9.1.1 Nos. 33 – 35 (Lots 53 & 350; D/P: 672 & 302361) Mary Street, Highgate – Proposed Additions and Alterations of an Existing Eight Multiple Dwelling Development to a Seven Multiple Dwelling Development and Construction of Two Grouped Dwellings

Ward:	South	**Date:**	12 June 2015
Precinct:	Precinct 12 – Hyde Park	**File Ref:**	PR23873; 5.2014.716.1
Attachments:	1 – Consultation Map 2 – Development Application Plans 3 – Applicant Submission 4 – Applicant Justification 5 – Heritage Impact Statement 6 – Heritage Assessment from Applicant 7 – Marked up plans showing proposed versus required setbacks 8 – 3D Perspectives 9 – Design Advisory Committee Comments		
Tabled Items:	Nil		
Reporting Officer:	A Dyson – Planning Officer (Statutory)		
Responsible Officer:	G Poezyn – Director Planning Services

Proposed Renovation Of Existing Multiple Dwelling units &
New Under Croft Carpark With 2 Group Dwellings Over

33 MARY STREET HIGHGATE

PROPOSED GROUND FLOOR PLAN SCALE 1:100

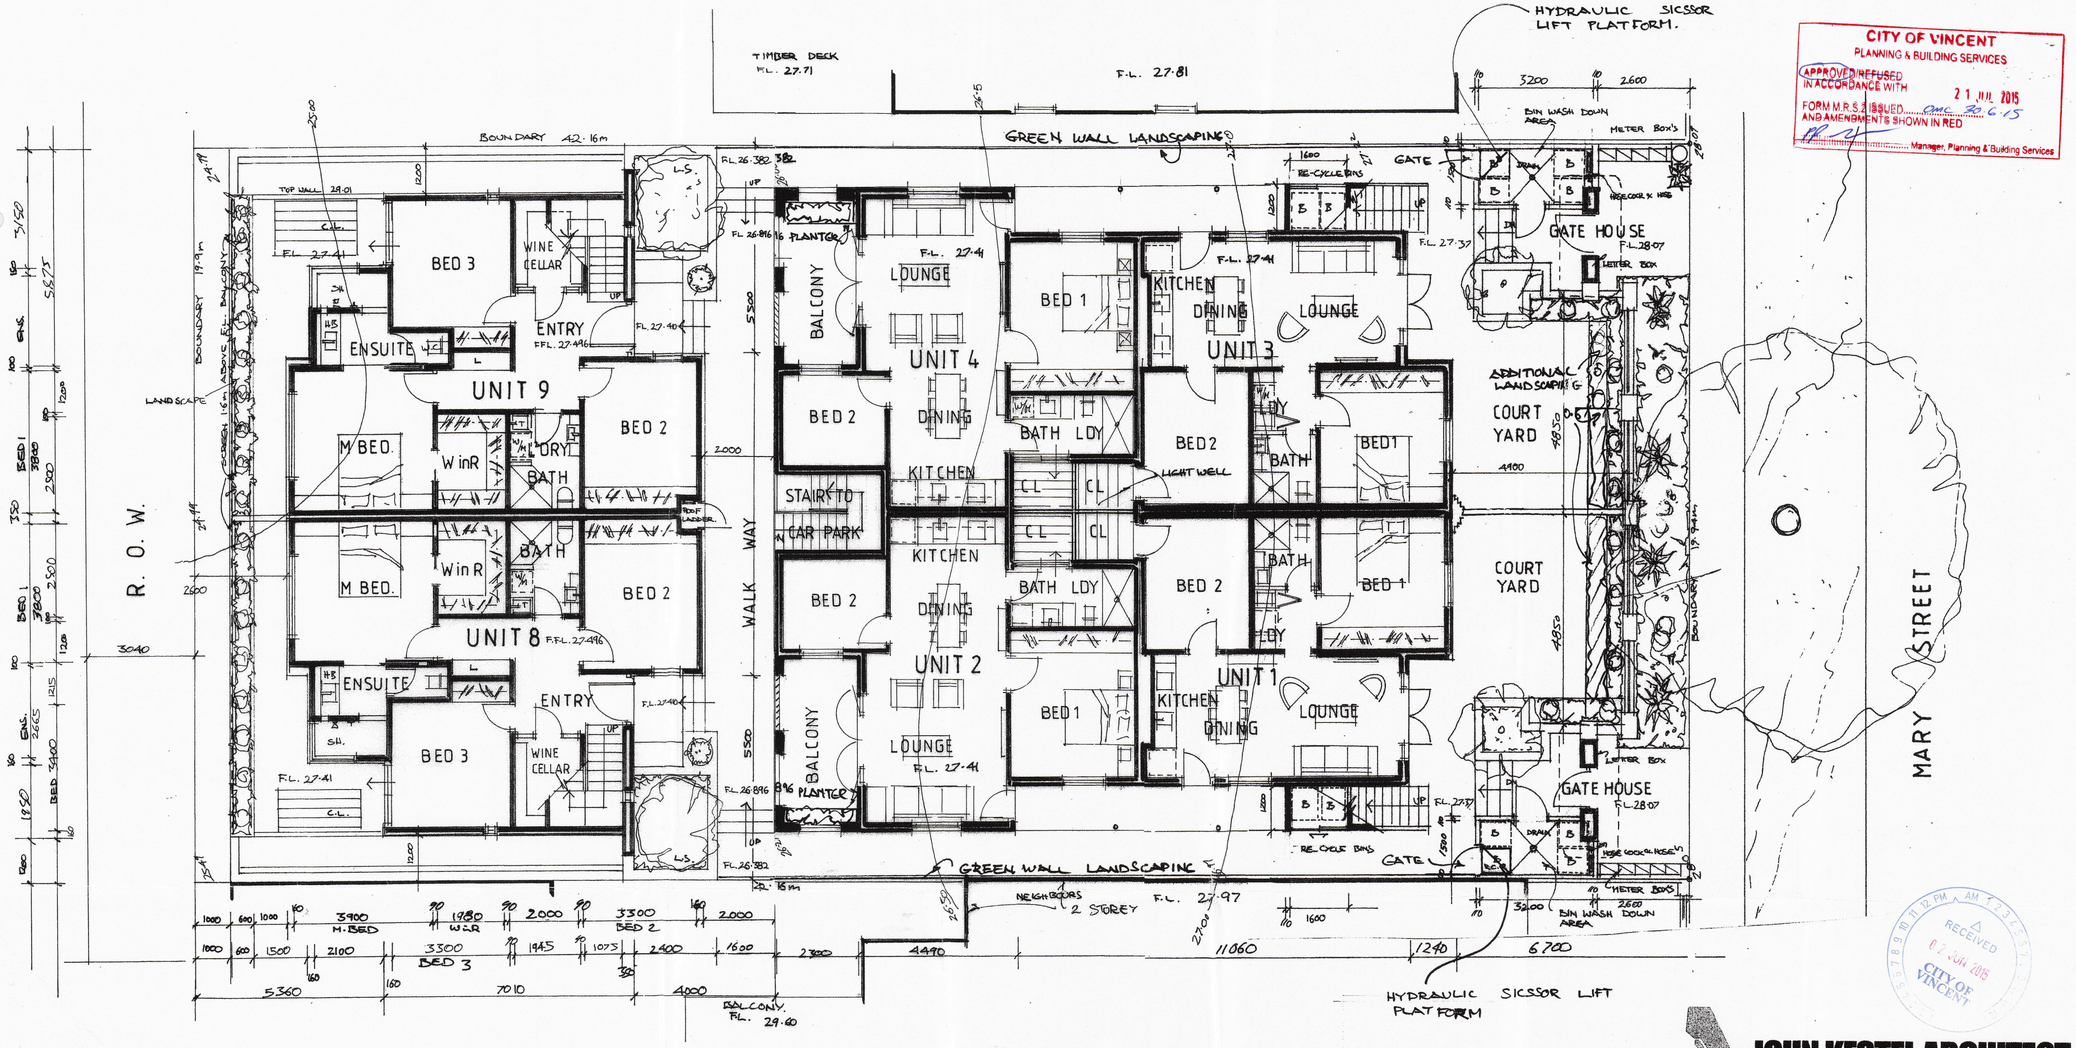
REVISED 3·3·15 GATE SIZE 22·5·15 STORES BICYCLE STORE

Proposed Ground Floor Plan

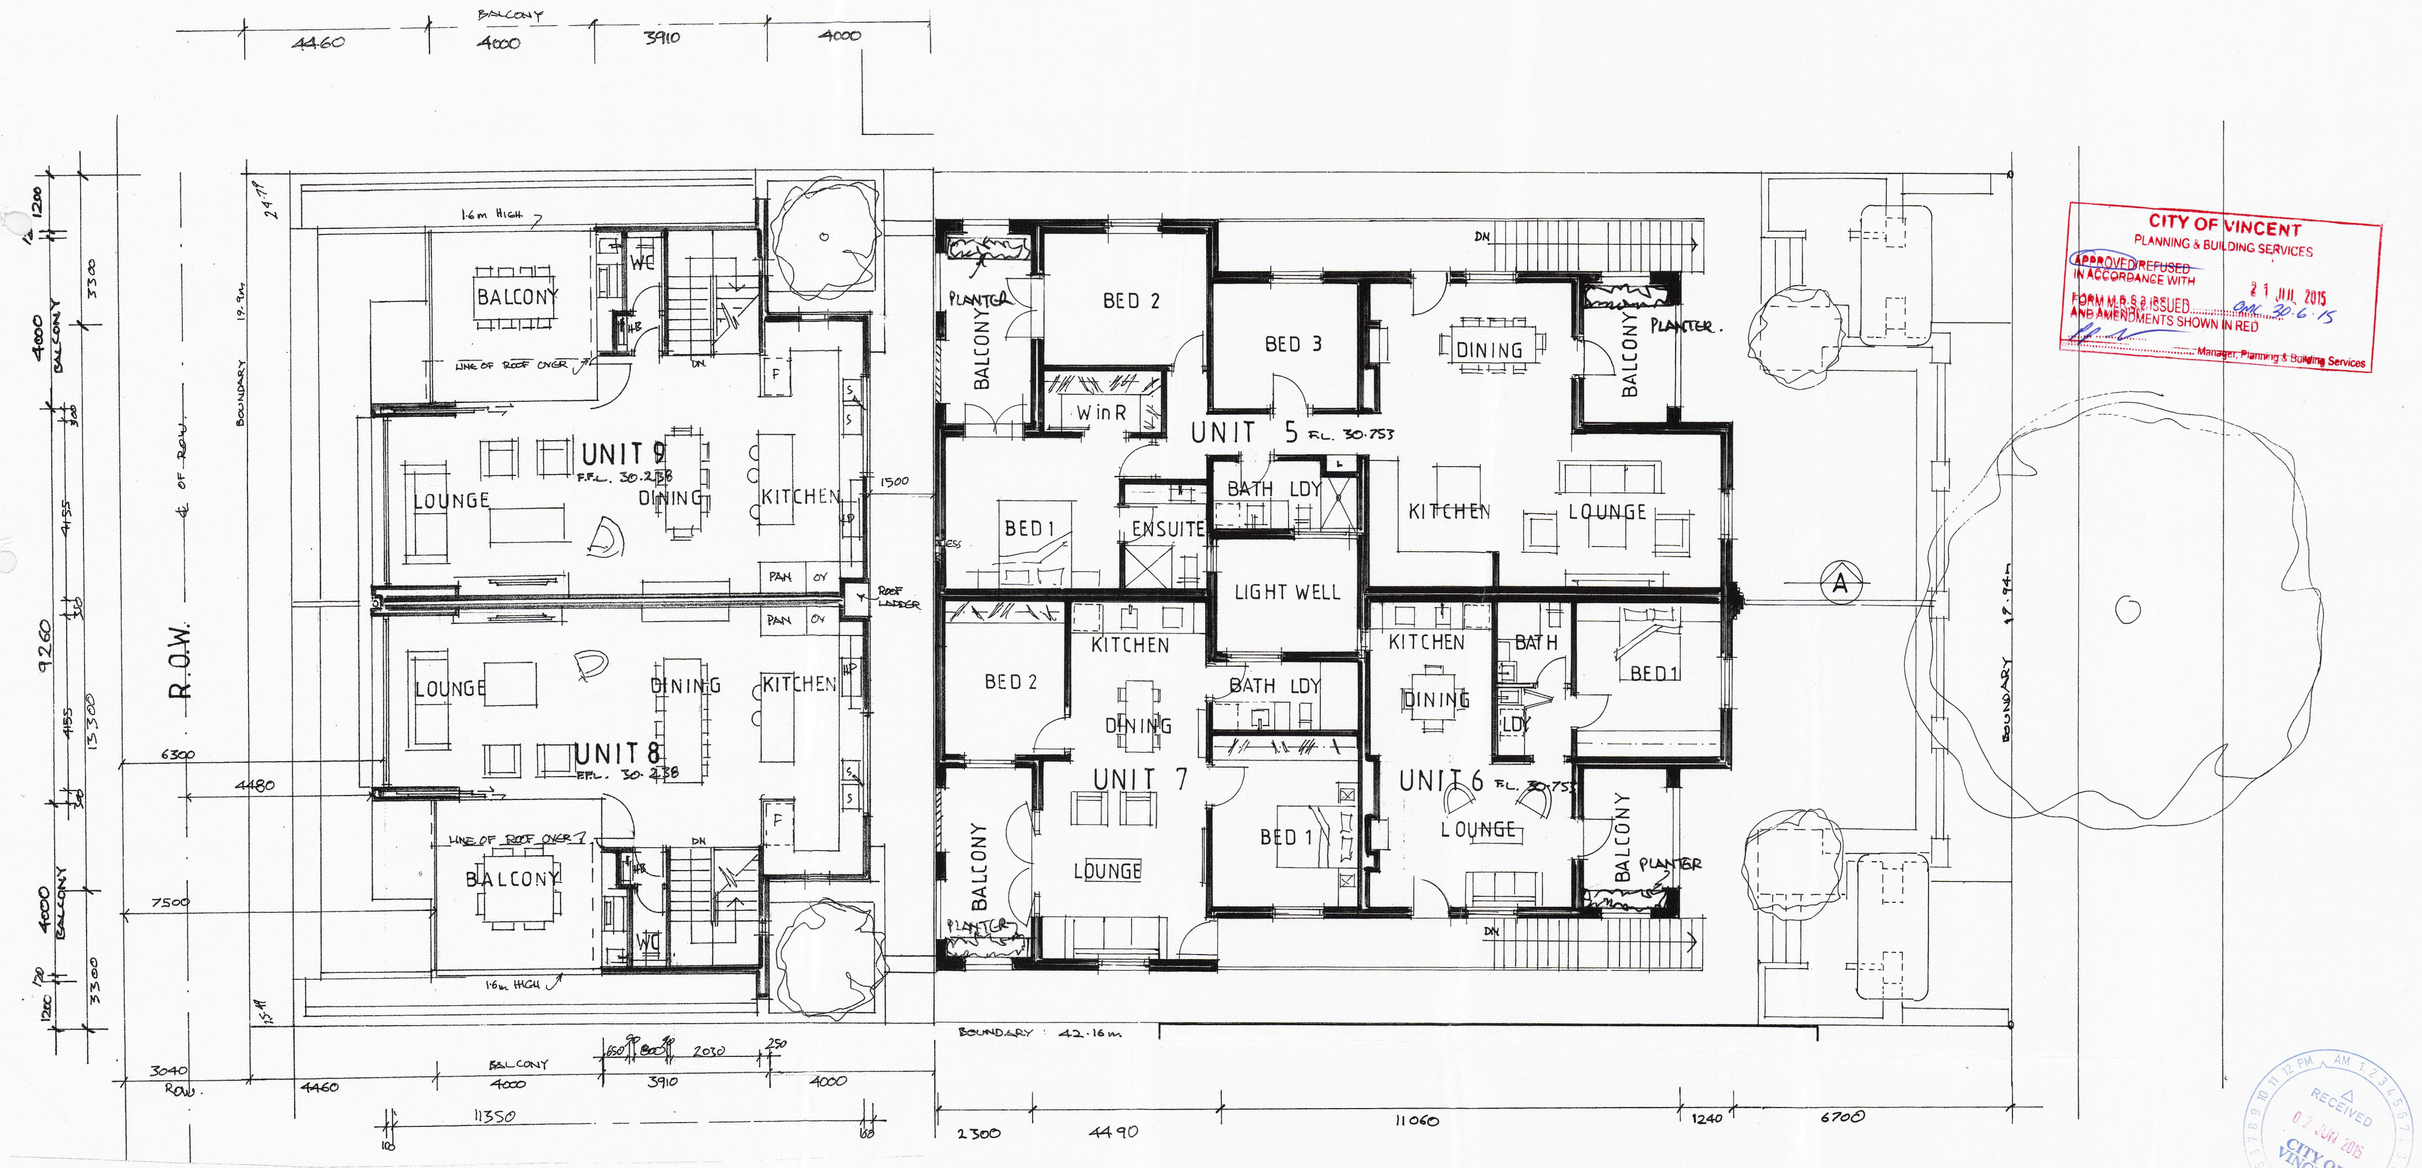
REVISED 3-3-15 UNIT 8,9 & BIN AREAS
REVISED 10-3-15 HYDRAULIC SICSSOR LIFT PLATFORM FOR BINS.
REVISED 2-04-15 ADDITIONAL LANDSCAPING.
REVISED 31-5-15 PLANTER. BALCONY

Proposed Upper Floor Plan

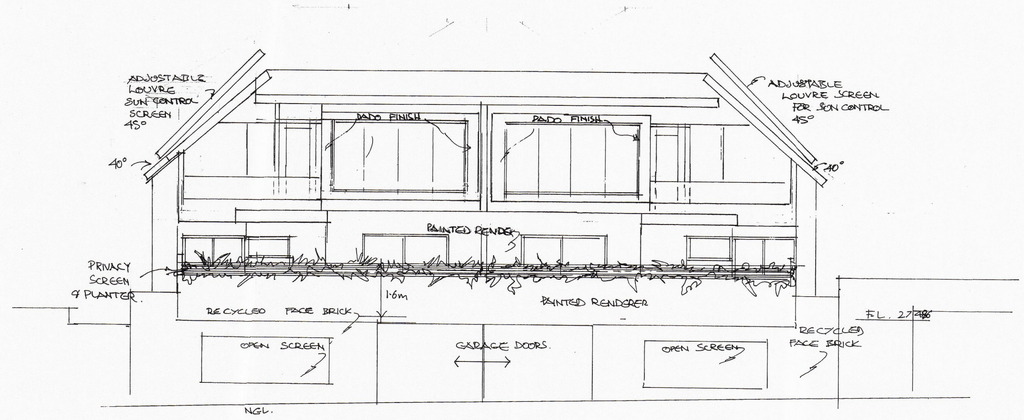
The southern façade of the balconies to units 8 & 9 shall comply with the requirements of the 2013 Residential Design Codes in relation to privacy provisions to the satisfaction of the City to prevent overlooking of Nos. 31 (Lot 51) and 37 (Lot 54) Mary Street, Highgate;

REVISED 3·3·15 UNIT 8 & 9
REVISED 2·4·15 OBSCURE GLASS KITCHEN WINDOW UNITS 8 & 9.
REVISED 31·5·15 PLANTERS TO BALCONY & REVISED REAR UNIT LAYOUT.

Proposed North East, South West Elevations & Section A-A

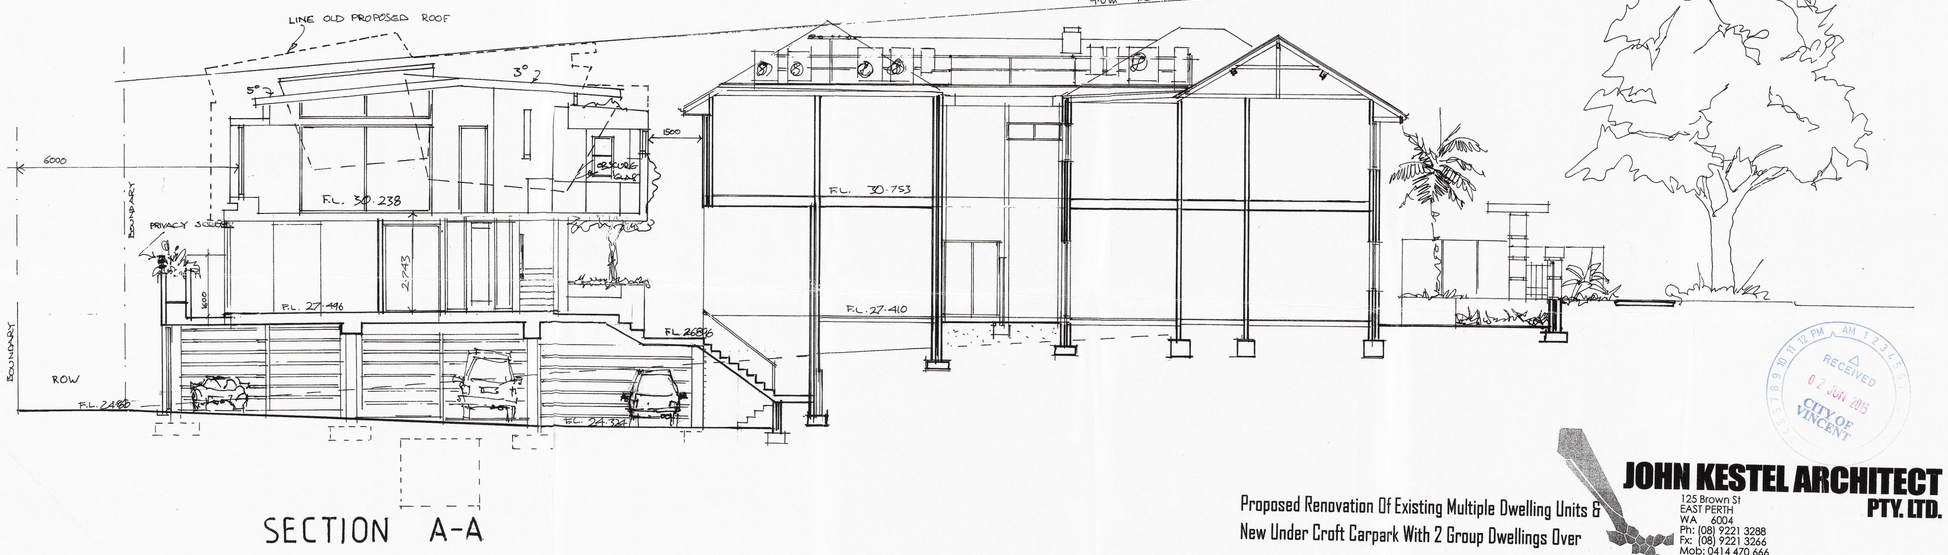
REVISED 3.3.15 REAR UNIT REVISED ROOF LINE REAR UNITS. 31.5.15
